MECKLENBURG COUNTY HEALTH DEPARTMENT

APPLICATION FOR PERCOLATION TEST

SUBJECT: APT # 6962 (John Woodruff)
Windwood Circle, Lot No. 38
7/25/73

APPENDIX H
SITE EVALUATION

* See Diagram on Back (Include: Soil areas, property lines, roads, streams, gullies, wet areas, fill areas, wells, water bodies, slope patterns, etc)

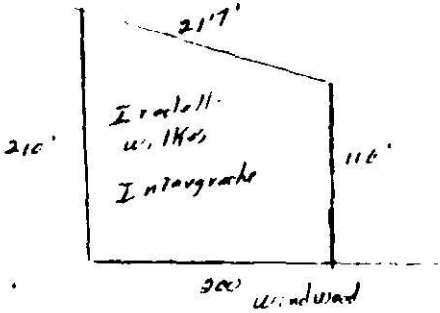
FACTORS	AREA 1	AREA 2	AREA 3	AREA 4
1. SLOPE (%)	(S) PS U — 4-15%	S PS U	S PS U	S PS U +
2. SOIL TEXTURE (12-36 in.) (Sandy, loamy, clayey, Note 2:1, Clay)	S 2:1 PS Expanding (U) Clay	S PS U	S PS U	S PS U
3. SOIL STRUCTURE (12.36 in.) (Clayey Soils)	S Massive PS (U)	S PS U	S PS U	S PS U
4. SOIL DEPTH (In.)	S Variable PS 18" 36" (U)	S PS U	S PS U	S PS U
5. RESTRICTIVE HORIZONS (In.) (Imprevious Strata, Rock)	S Saprolite PS @ 18 36" (U)	S PS U	S PS U	S PS U
6. SOIL DRAINAGE/GROUNDWATER (External & Internal)	(S) ground PS water U 7'+0"	S PS U	S PS U	S PS U
7. SOIL PERMEABILITY (Percolation Rate)	S V Slow PS (U)	S PS U	S PS U	S PS U
8. OTHER (Specify)	S PS U	S PS U	S PS U	S PS U
9. SITE CLASSIFICATION	unsuitable			
SOIL SERIES	Leaf Rolf W. Hks

Recommendations/Comments: Soil unsuitable as requested
John D. Woodruff
